## **AGENDA FOR REGULAR MEETING VILLAGE OF TINLEY PARK PLAN COMMISSION**

**ITEM #1 PUBLIC HEARING – CHIPOTLE NEW CONSTRUCTION, 7121 159<sup>th</sup> STREET  
– SPECIAL USE FOR A PUD, SITE PLAN/ARCHITECTURAL APPROVAL,  
AND PLAT OF SUBDIVISION**

## PLAN COMMISSION STAFF REPORT

The Petitioner, Richard Silverman on behalf of MJK Real Estate Holding Company, LLC is requesting a Special Use for a Planned Unit Development (PUD), Site Plan/Architectural Approval, and Plat of Subdivision. The requests are to retroactively create a PUD over the full lot (including all deviations/exceptions previously approved in error), and for the proposed new construction of an outlot building with a drive-up pre-order pick-up window for Chipotle.

1 CONCEPTUAL SITE PLAN - SP23  
1" = 20'-0"

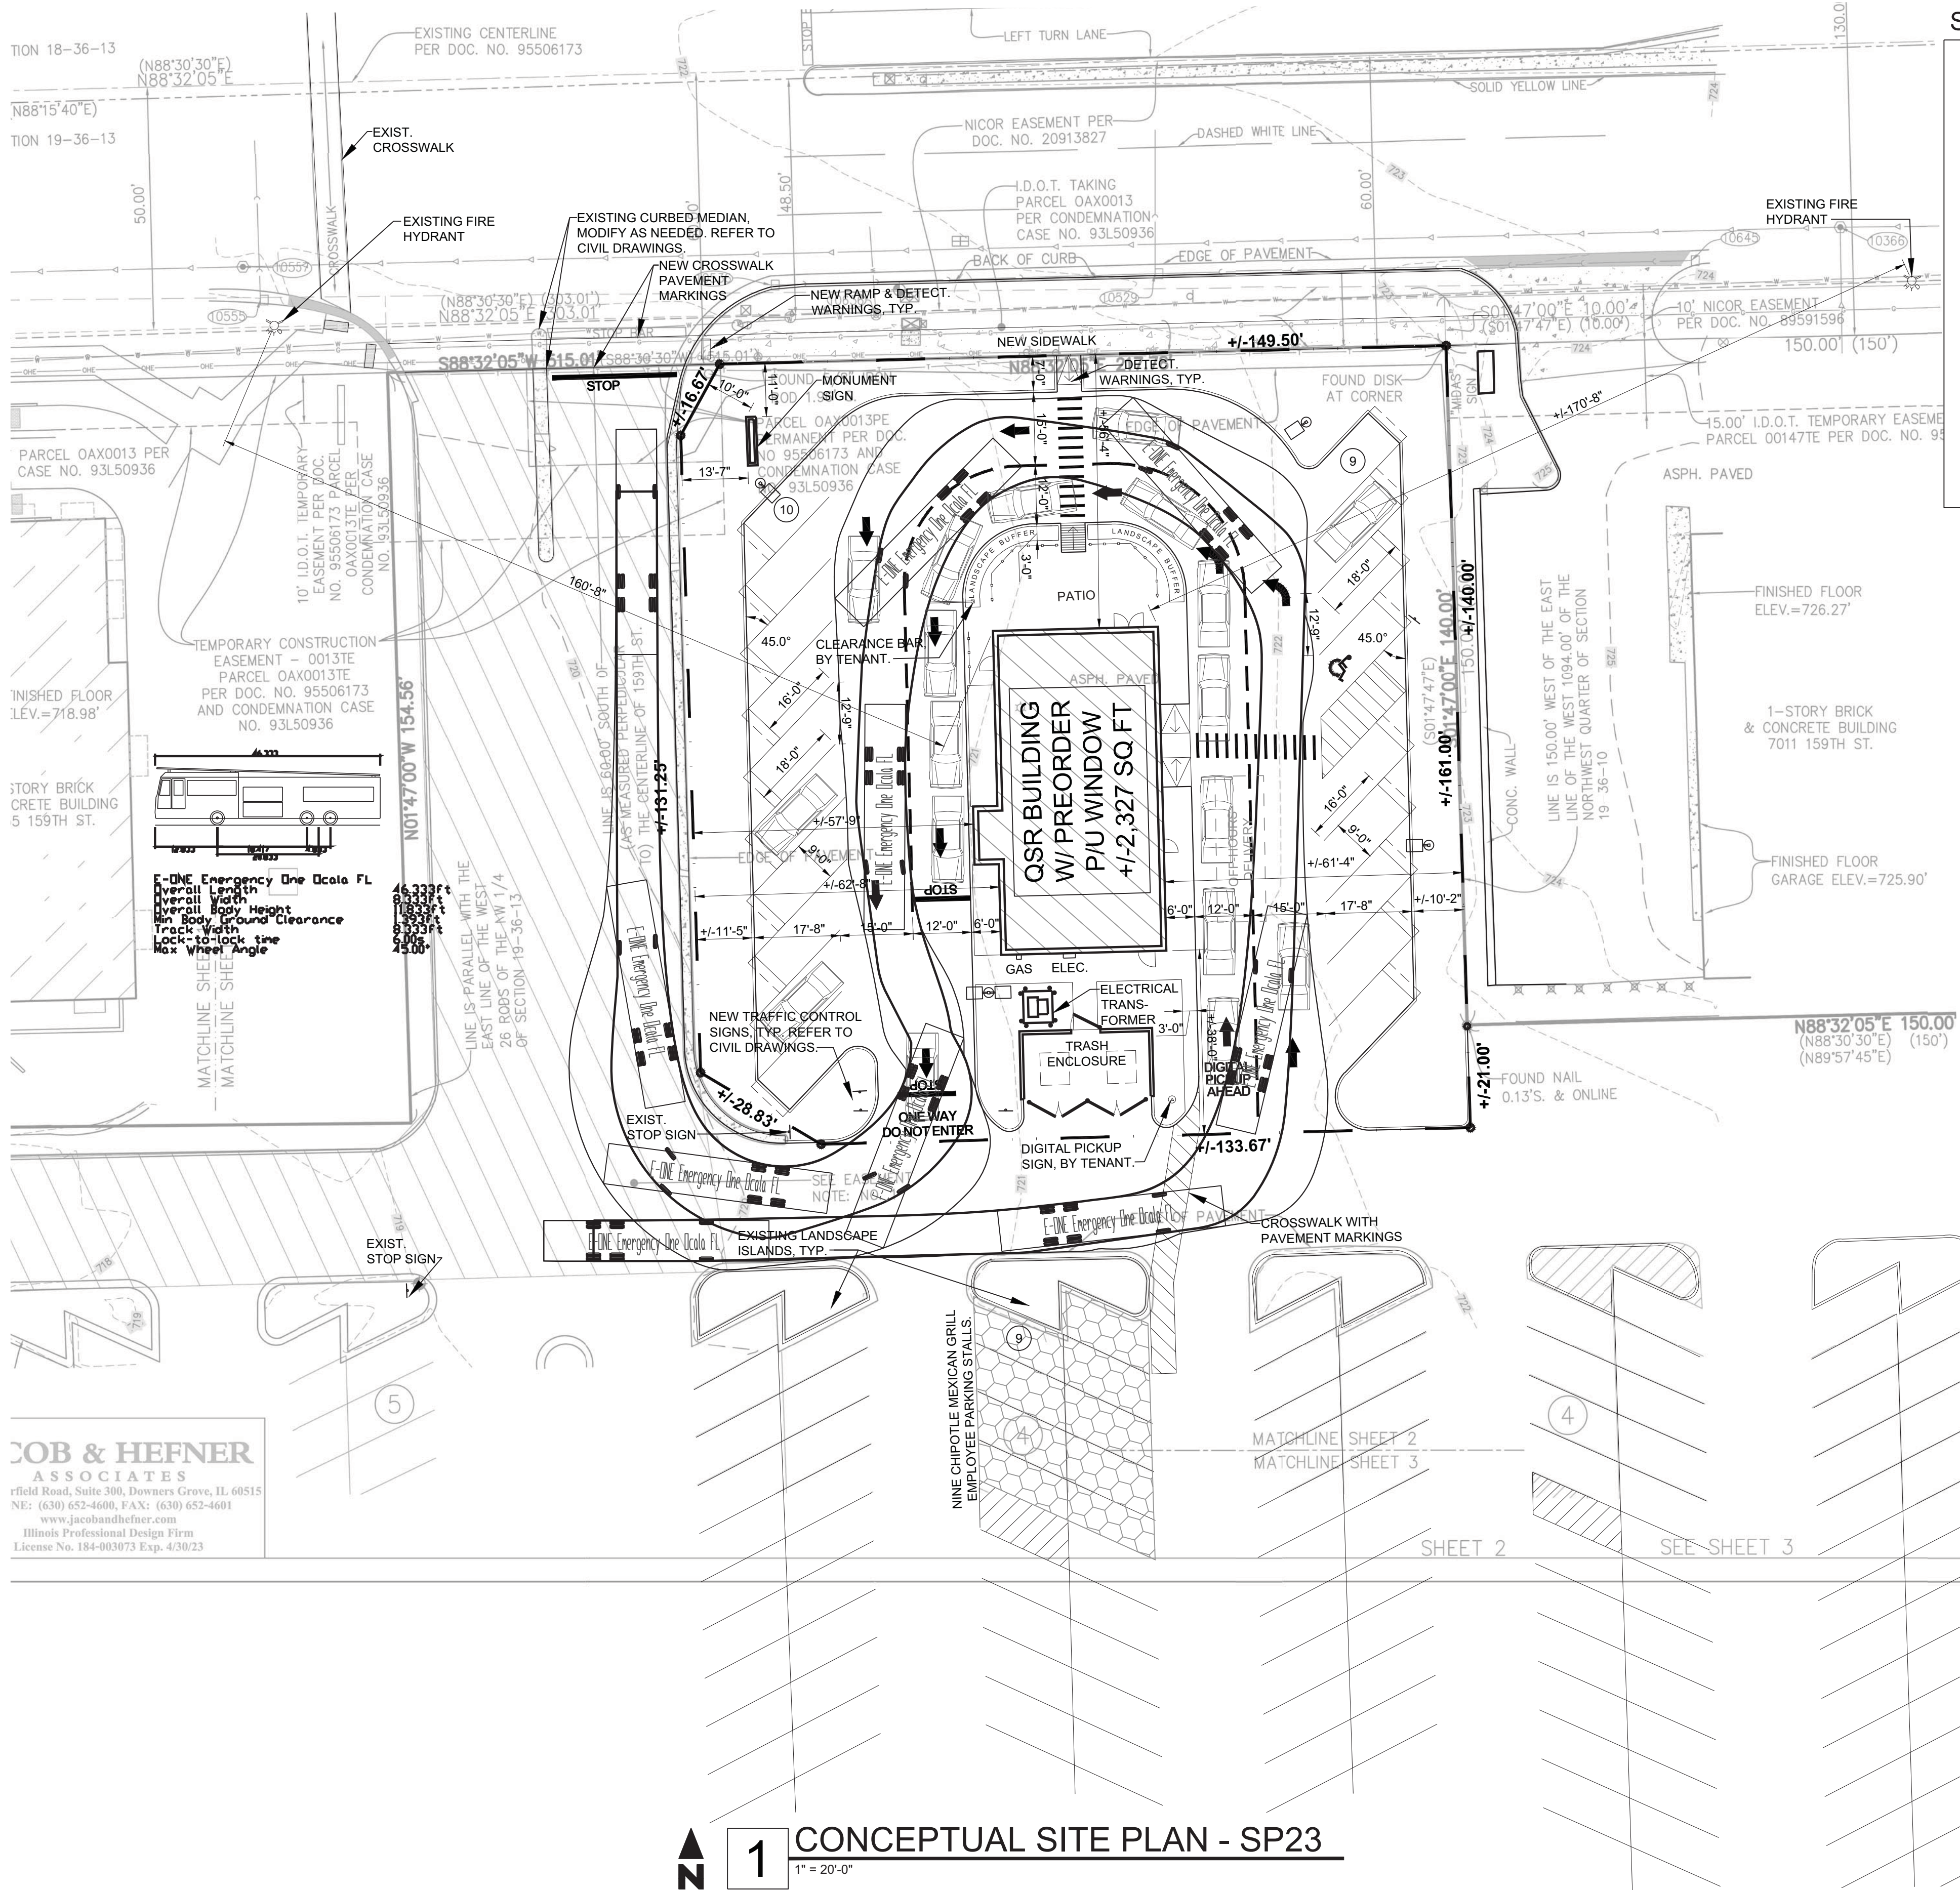
The Site Plan identifies 59 total seats (43 indoor and 16 outdoor), and eight employees. Based on these numbers provided, the Zoning code requires 28 stalls (one parking stall for every three seats, and one stall per employee). The Site Plan proposes 28 parking spaces as 19 parking stalls on-site and nine parking stalls for employees off-site to the south within the Floor & Décor/Hobby Lobby parking lot. An Exception to the Zoning Ordinance is required as not all of the parking is included on-site within the outlot (proposed subdivision's Lot 2).

The Petitioner's Exhibit Plans by Wilkus Associates on behalf of Chipotle's standards however appear to show a less intense use of only 38 indoor seats, not the listed 43 per the Soos Associates Site Plan. Despite this discrepancy on the seat count in the plans, staff has utilized the more intense request as part of their analysis.

At the Workshop, the Plan Commissioners felt the proposed parking with the off-site parking and its related requirements were appropriate. The Petitioner's resubmittal of the Site Plan continues to have the same 59 total seats with eight employees.
